COUNTY OF CHEMUNG  
Chemung County Stormwater Coalition  
851 Chemung Street  
Horseheads, New York 14845  
Ph. 607.796.2216

**PROJECT:** Horseheads Hotel  
Village of Horseheads  
Municipal Inspection  
April 11, 2022

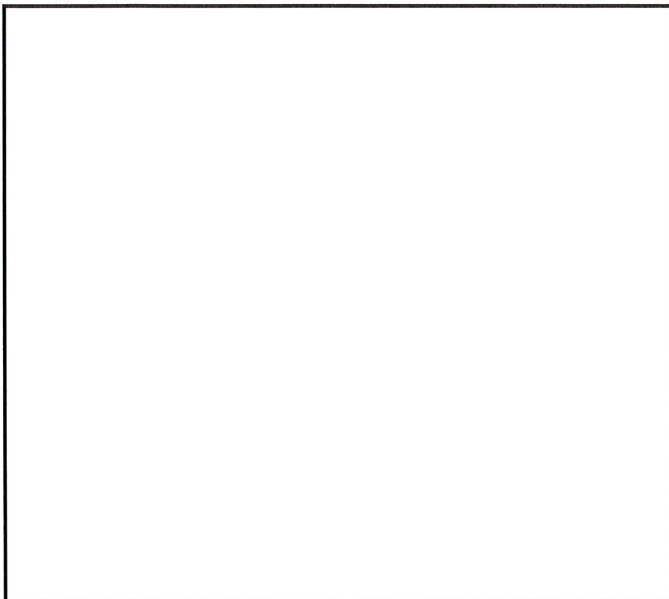
Animal burrows along stormwater basin embankment will need to be addressed prior to final close out.
